TYPICAL R/C SINGLE STAGE A/C UNIT

REF:	DATE:	PROJECT REFERENCE:	HTC2 > HTC3 CHANGE OVER
DRAWN: TREVOR SWEETMAN	22/01/18	CONTRACTOR:

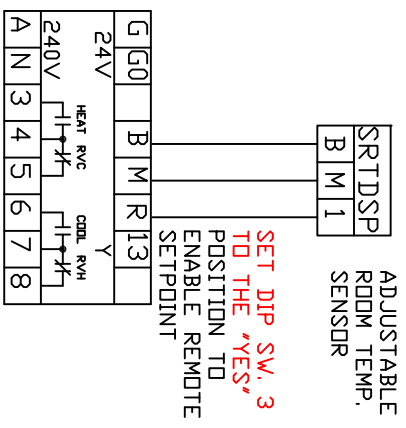
- OTHER NOTES :**
- 1) TO REPLACE EXISTING HTc2 CONTROL SYSTEM WITH A HTc3 , A NEW SENSOR WILL ALSO BE REQUIRED TYPE SRT-D.
 - 2) IF CONTROLLER IS POWERED BY 240V THEN USE 240V POWER SUPPLY TERMINALS INSTEAD OF 24V TERMINALS.
 - 3) IF EXISTING HTc2 USED AN ADJUSTABLE ROOM SENSOR TYPE SRTDSP WHICH STILL ONLY USED 2 WIRES, THEN TO CHANGE OVER TO USING HTc3 BUT WITH AN ADJUSTABLE SENSOR (TYPE SRT-DSP) AN ADDITIONAL FIELD WIRE WILL BE REQUIRED. IF THE EXISTING SENSOR WAS CONNECTED USING A 2 CORE SHIELDED CABLE THEN IT IS POSSIBLE TO USE THE SHIELD AS A 3RD WIRE USING THE SHIELD AS THE M (GROUND) CONNECTION.
